INEL-95/0375

August 1995

**Evaluation of Sequoyah Nuclear Plant
Offsite Dose Calculation Manual, Revision 28**

**Docket No. 50-327, Facility License No. DPR-77
Docket No. 50-328, Facility License No. DPR-79**

Figure 1. Liquid effluent release routes at SQN. (Based on Figure 6.1 of the SQN ODCM Revision 28.)

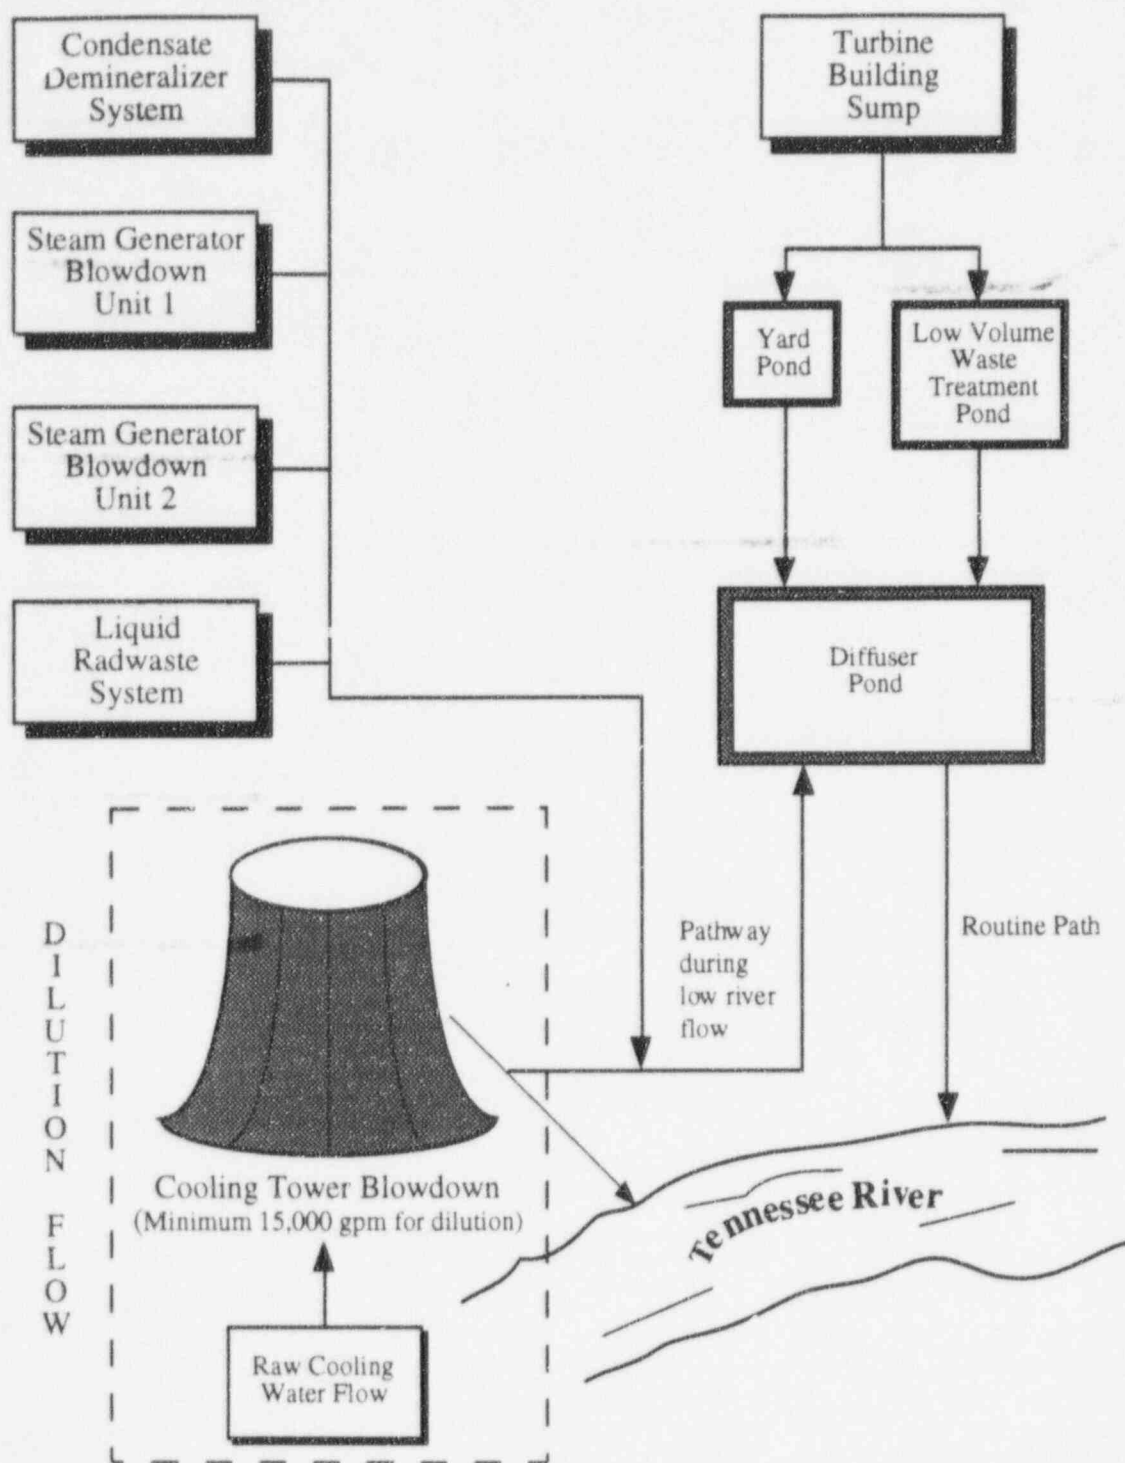
- ODCM Figure 6.1, Liquid Effluent Release Points, should be simplified. An example of the possible simplification is illustrated in Figure 1 of this report of Sequoyah 1/2 ODCM. If more detail is desired by the licensee, use a separate figure for each major radioactive gaseous release point. Figures 2 and 3 of the Technical Review of Sequoyah 1/2 ODCM illustrate breaking up ODCM Figure 6.1 into several simpler illustrations.

Figure 2. Liquid radwaste system at SQN. (Based on Figure 6.2 of the SQN ODCM Revision 28.)

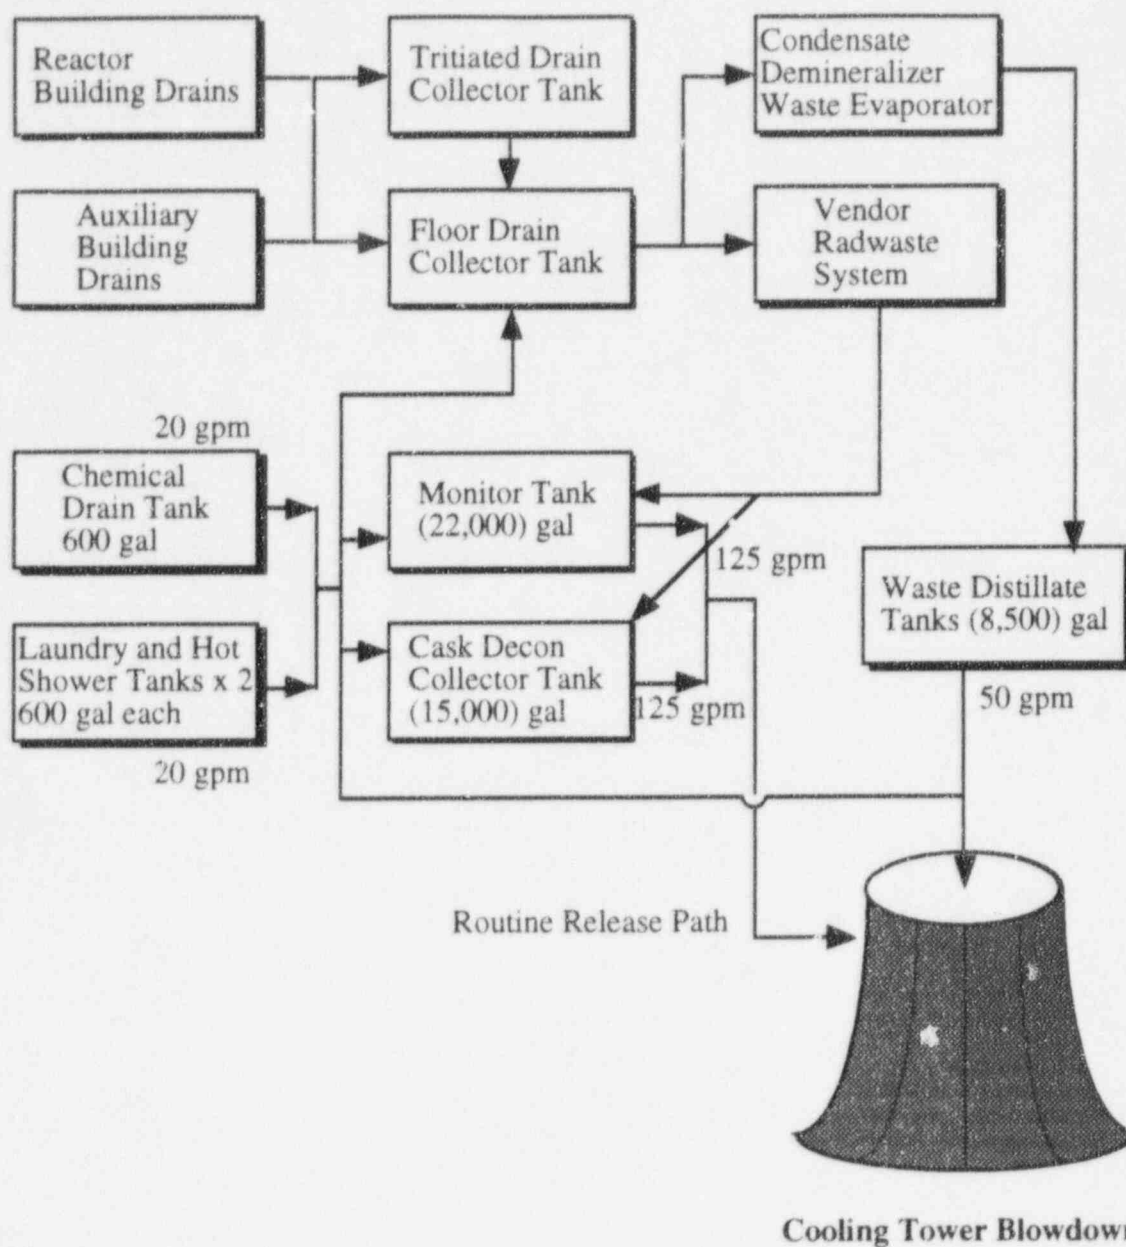
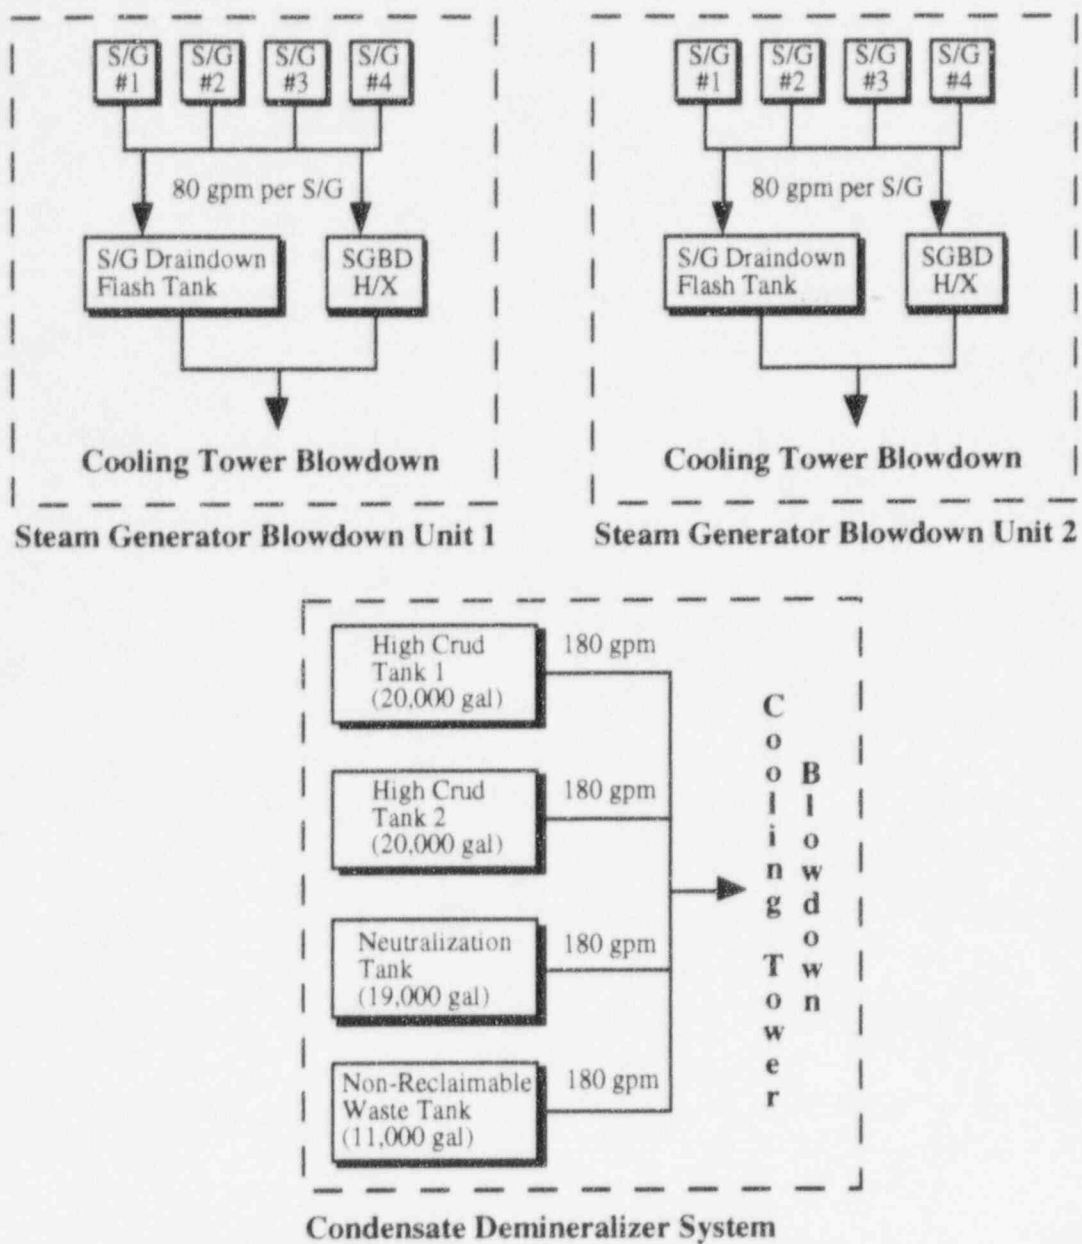
It is important to note that a complete listing of monitors and samplers is not included in Table 1.1-1. O-RM-90-211, which monitors the inlet to the diffuser pond, is not listed in Table 1.1-1 or ODCM Figure 6.1 and there is no required operability requirement. This monitor should monitor the cooling tower blowdown discharge. Further, there is no evidence of a monitor on the diffuser pond outlet, which would monitor possible concentration factors in the diffuser pond. Also, it is recommended that the flow rates for each liquid discharge point be included in a figure or tabular form. Table 2 lists the flow rates and storage capacity of tanks for five effluent liquid pathways. In ODCM Figure 6.1, a reference is made to ODCM Figure 2.2; it should refer to ODCM Figure 6.2

Figure 4. Gaseous effluent release routes at SQN (based on Figure 7.1 of the SQN ODCM Revision 28.)

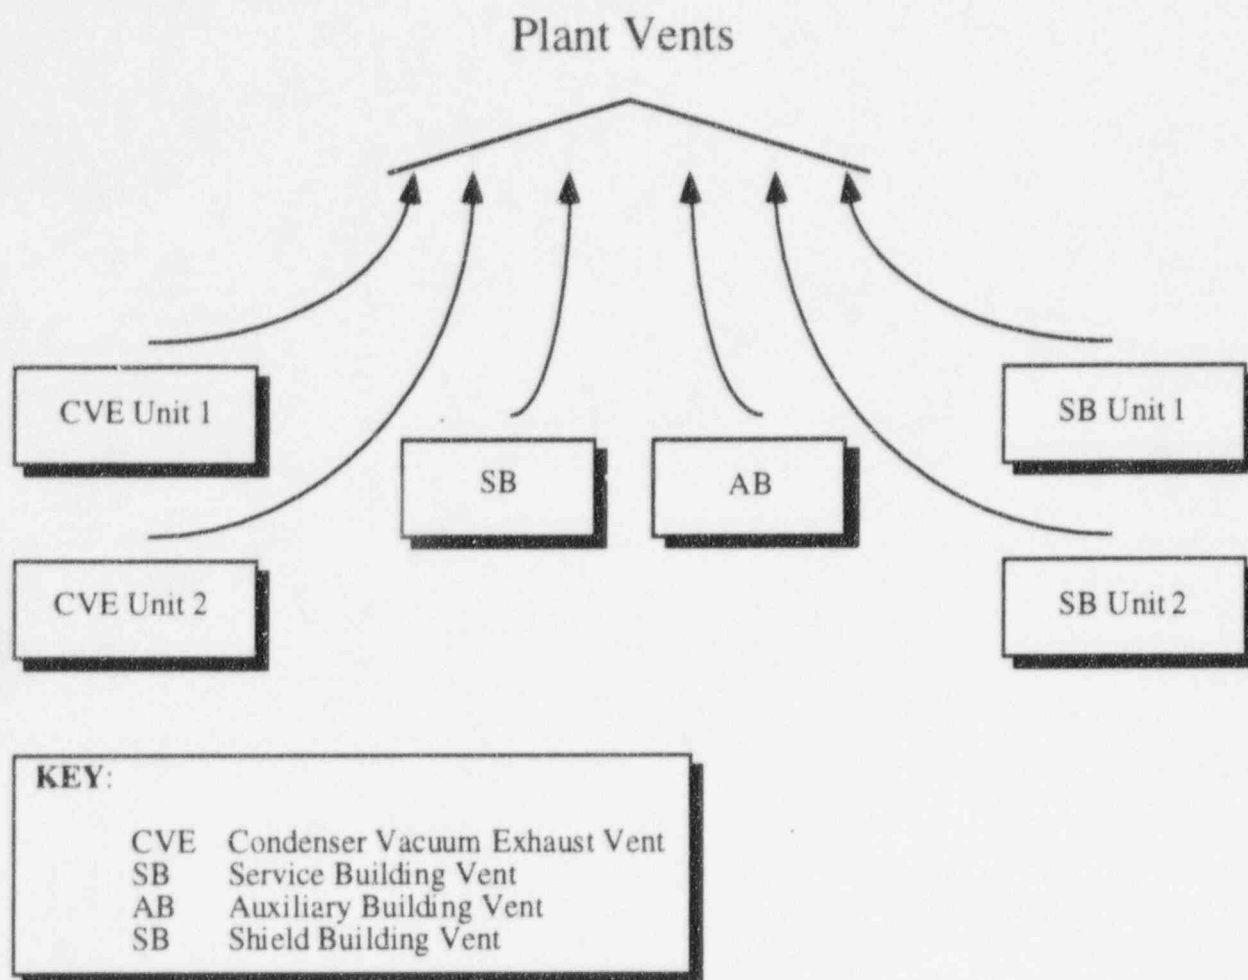
- ODCM Figure 7.1, "Gaseous Effluent Release Points," should be simplified. Add a symbol/term key. An example of the possible simplification is illustrated in Figure 4 of the Technical Review of Sequoyah 1/2 ODCM. If more detail is desired by the licensee, use a separate figure for each major radioactive gaseous release point.

Figure 5. Gaseous radwaste and off-gas treatment system at SQN. (Based on Figure 7.3 of the SQN ODCM Revision 28.)

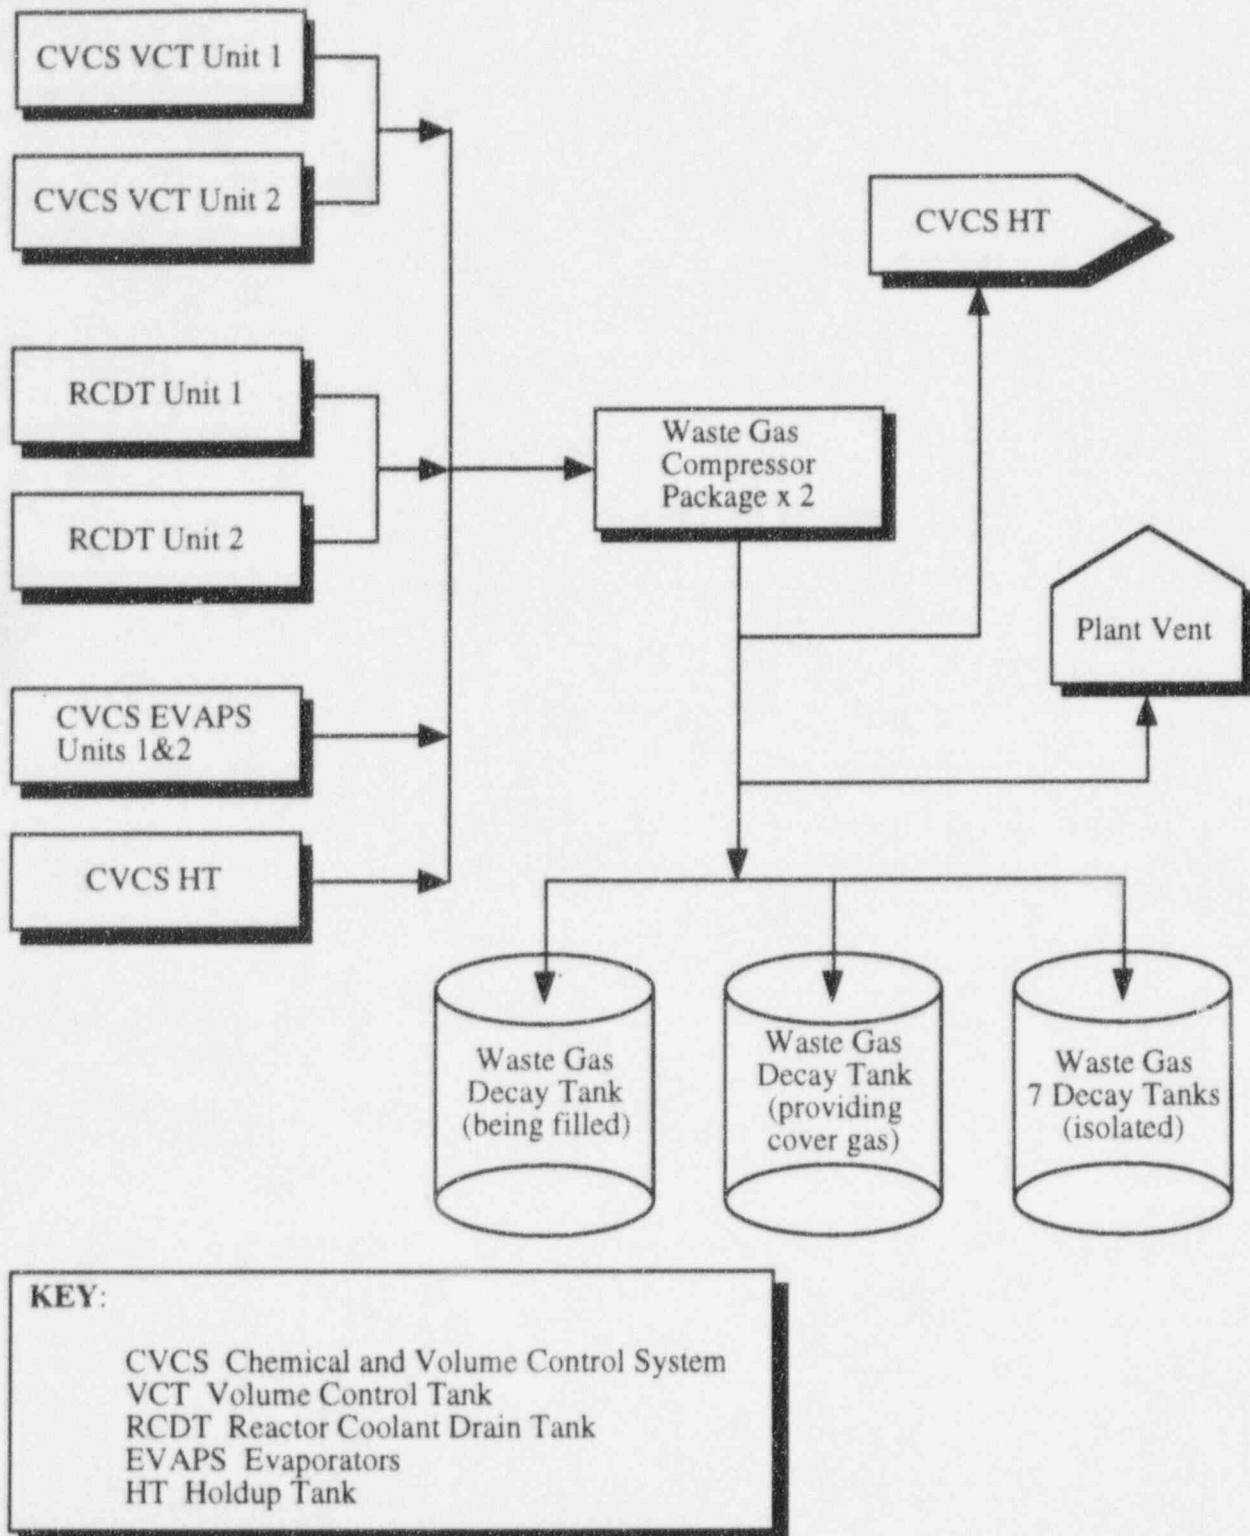
- ODCM Figure 7.3, "Gaseous Radwaste Treatment System," should be simplified. Add a symbol/term key. An example of the possible simplification is illustrated in Figure 5 of the Technical Review of Sequoyah 1/2 ODCM. If more detail is desired by the licensee, use a separate figure for each major radioactive gaseous release point.
